ARCHITECT'S SUPPLEMENTAL INSTRUCTIONS

PROJECT:	The Reserves at Magnolia New Apartment Complex Denton, TX	Report No.	One (1)
OWNER:	Overland Property Group Dan Maximuk 234 N. Santa Fe Ave, Suite A Salina, KS 67401	Date	Oct. 22, 2024
CONTRACTOR:	Snyder Construction Group 4820 N. Town Centre Dr. Ozark, MO 65721	Architect's Proj No.	21-3205
		Contract For:	General Construction Mechanical, Electrical

Please Note: Drawings and Specification Edits associated with this ASI are dated as **7-17-2024**. This date above is the date this ASI was issued.

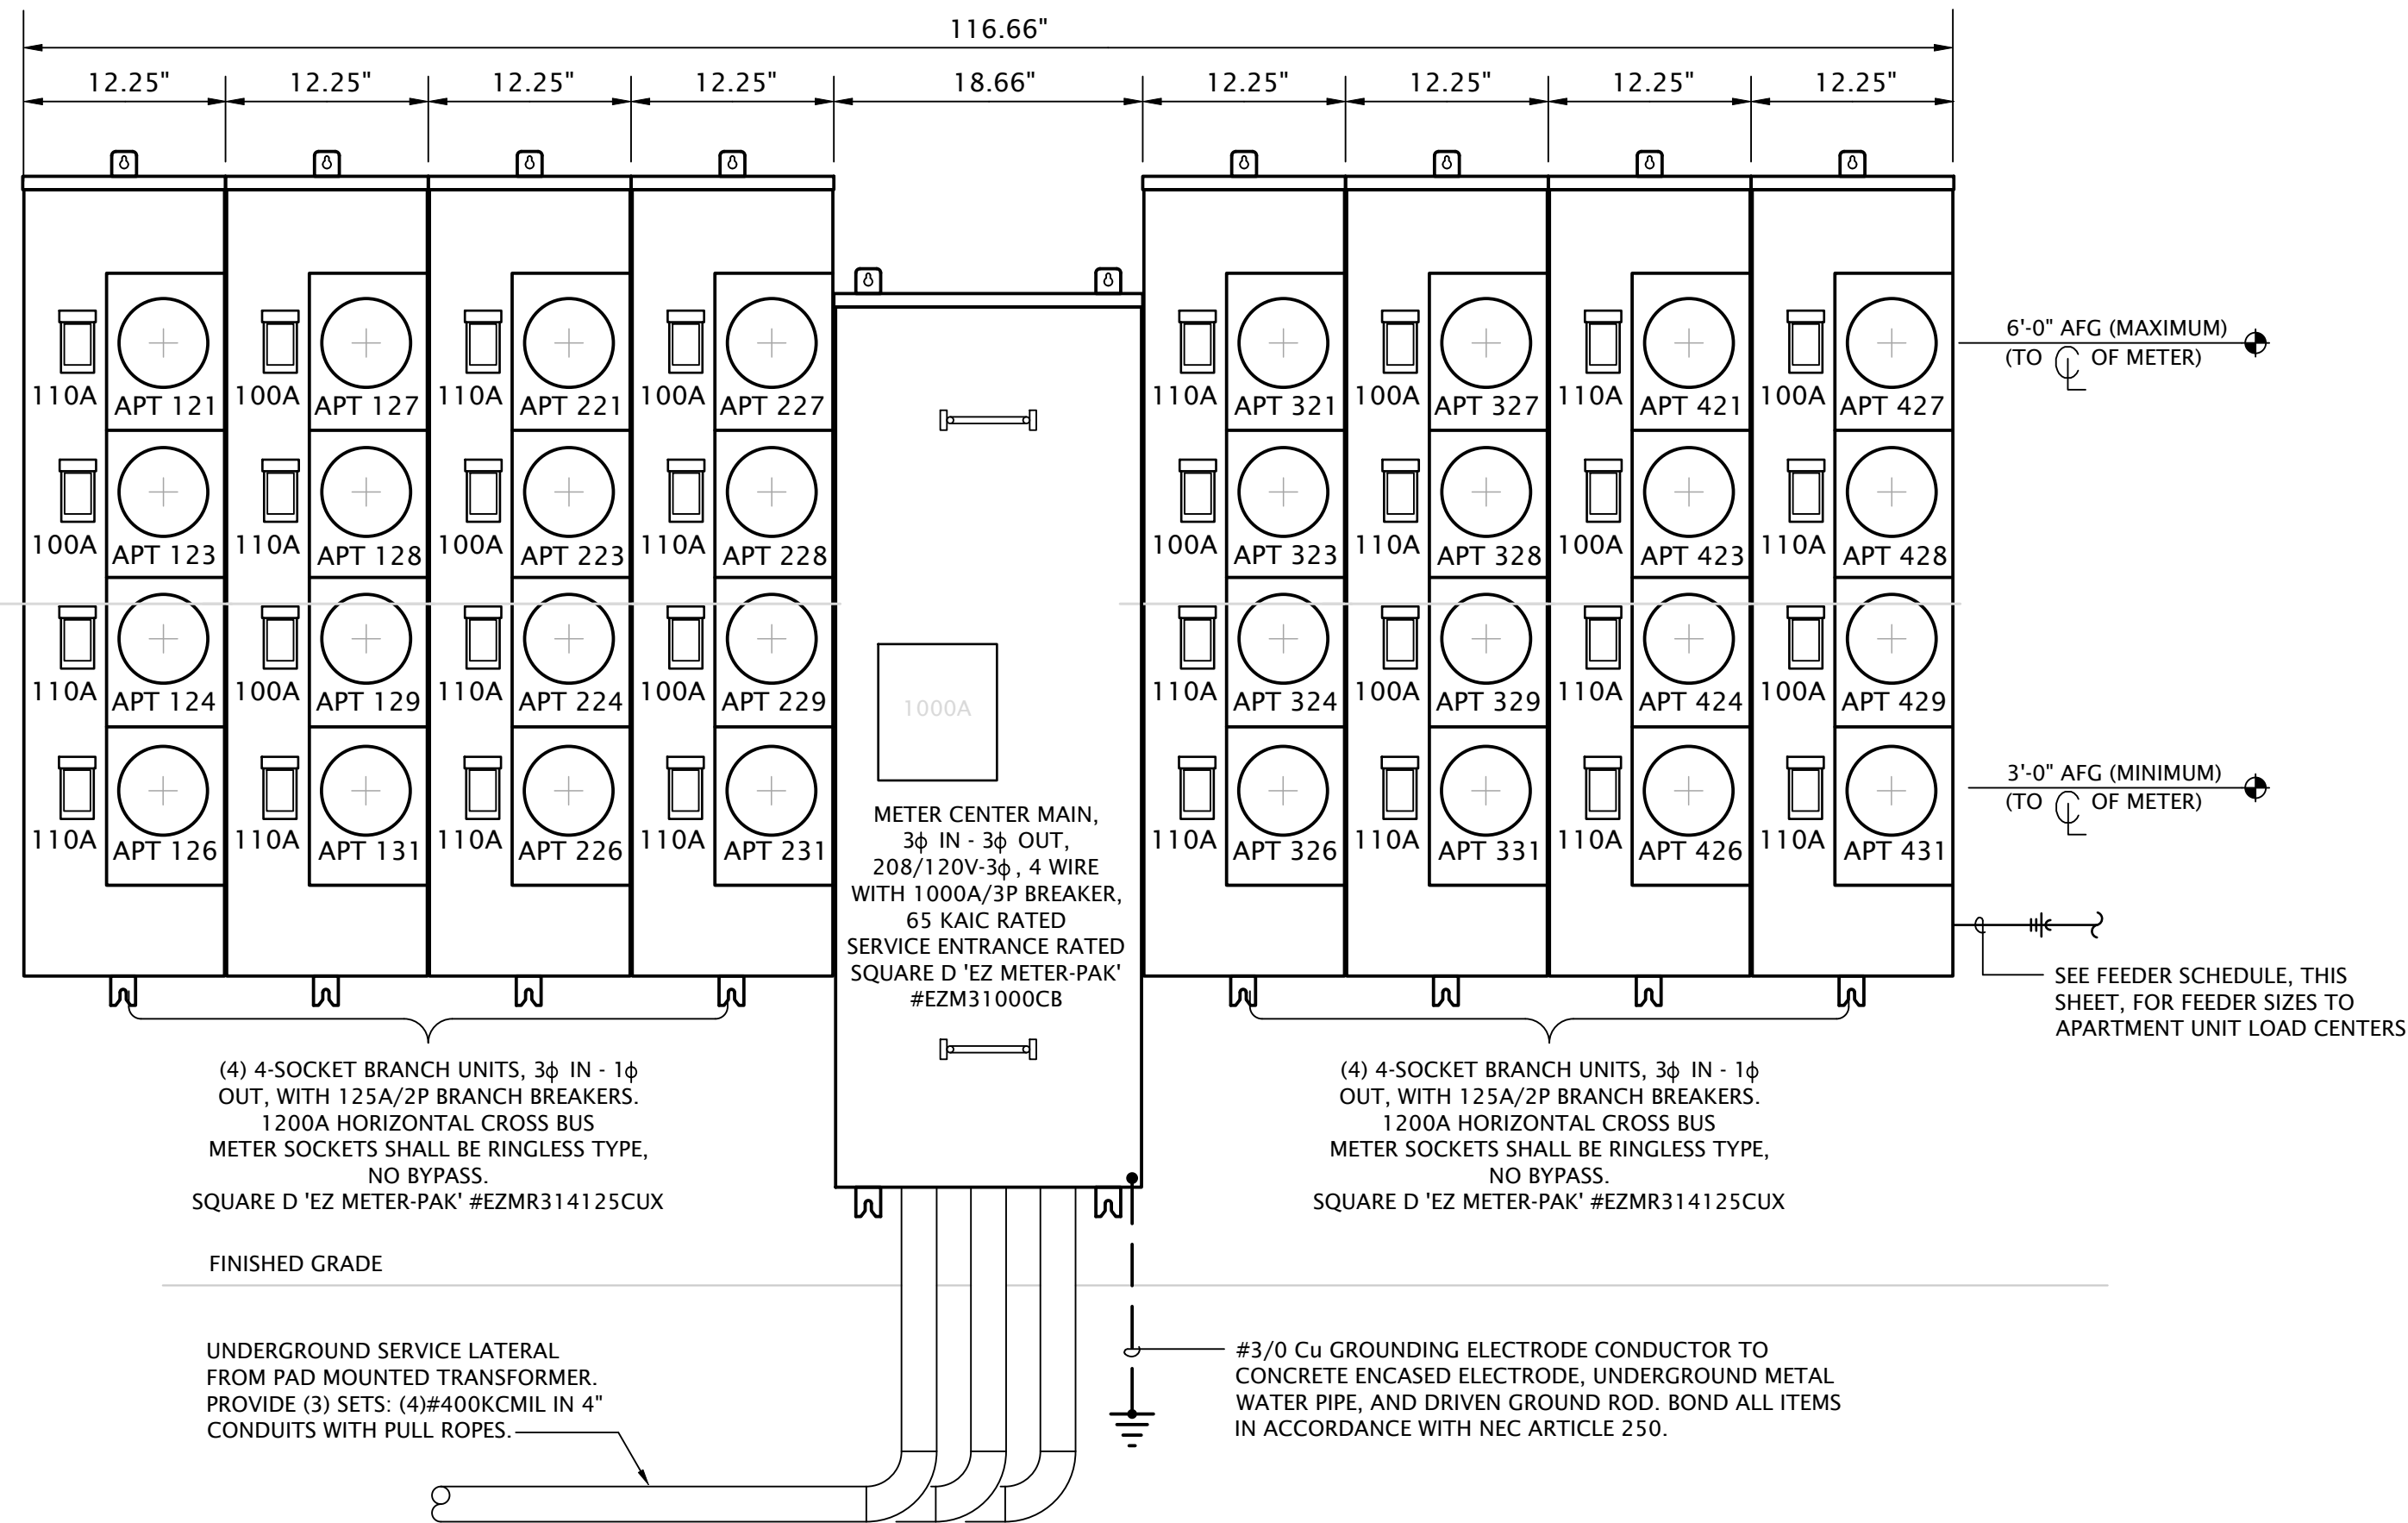
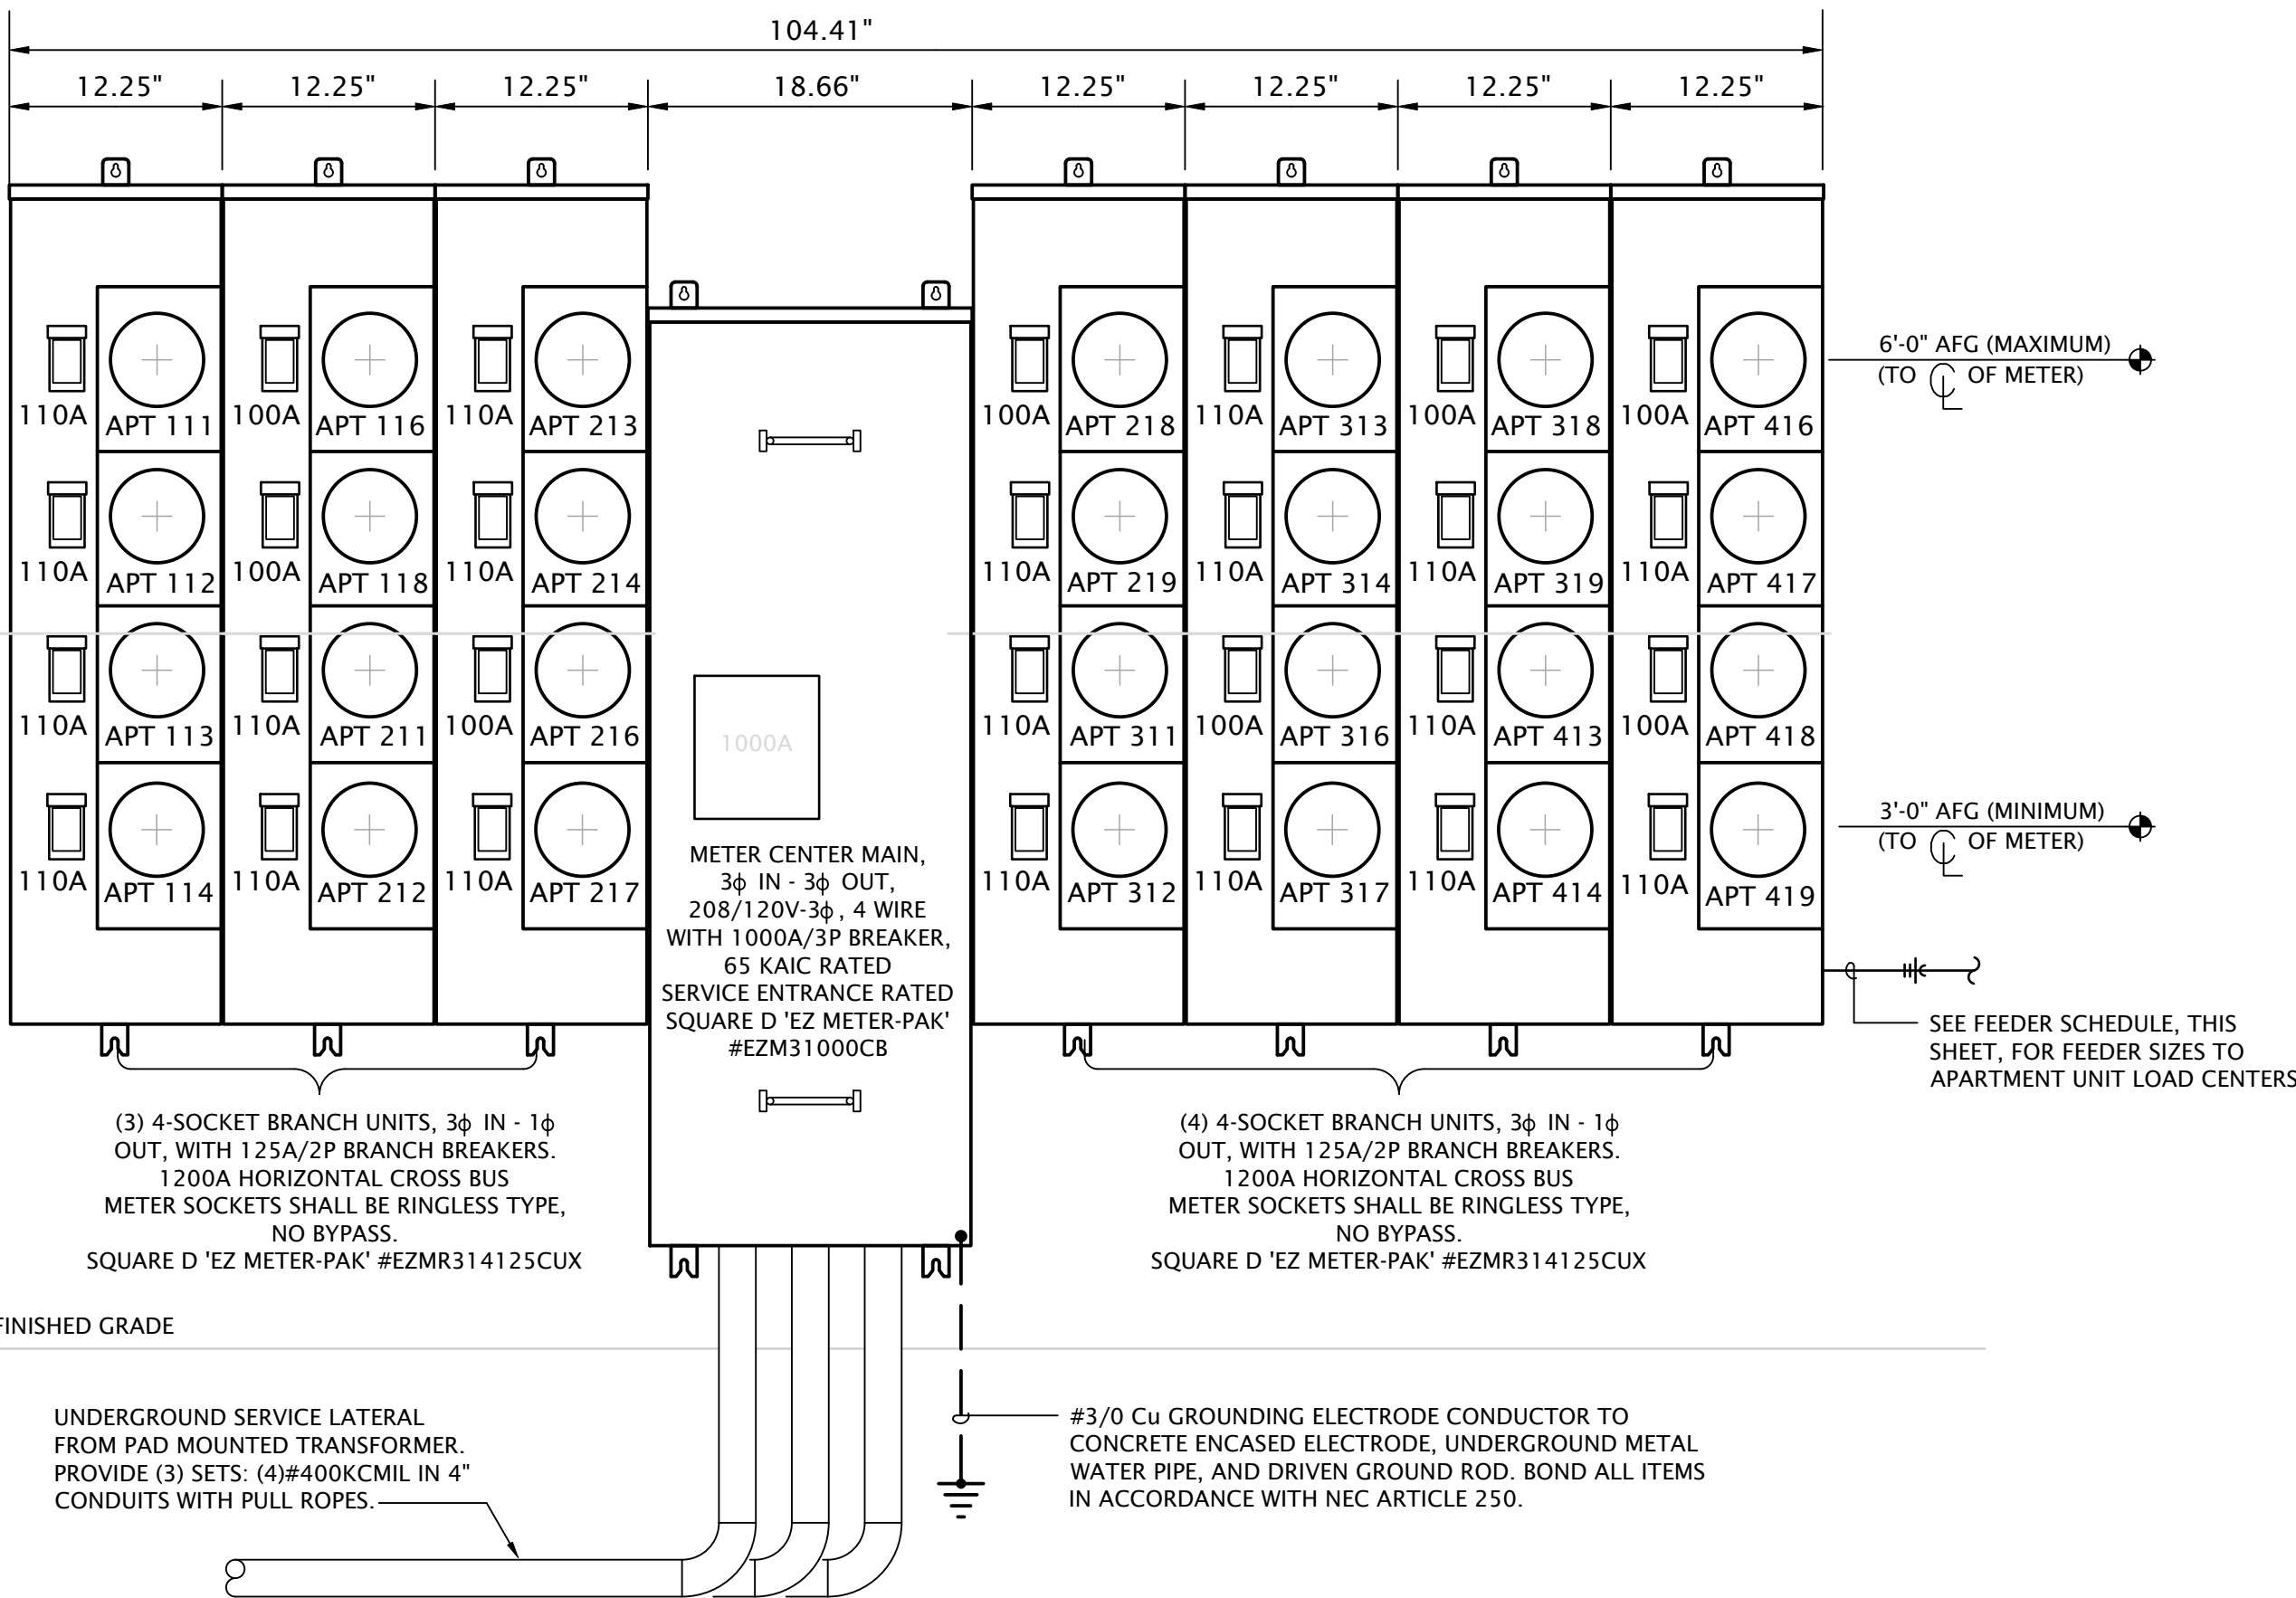
- 36) Utilize SER aluminum feeders in lieu of aluminum feeders. (VE Item #42). Reference revised Sheet E6.2
- 37) Omit sales taxes from all material purchases. (VE Item #43)
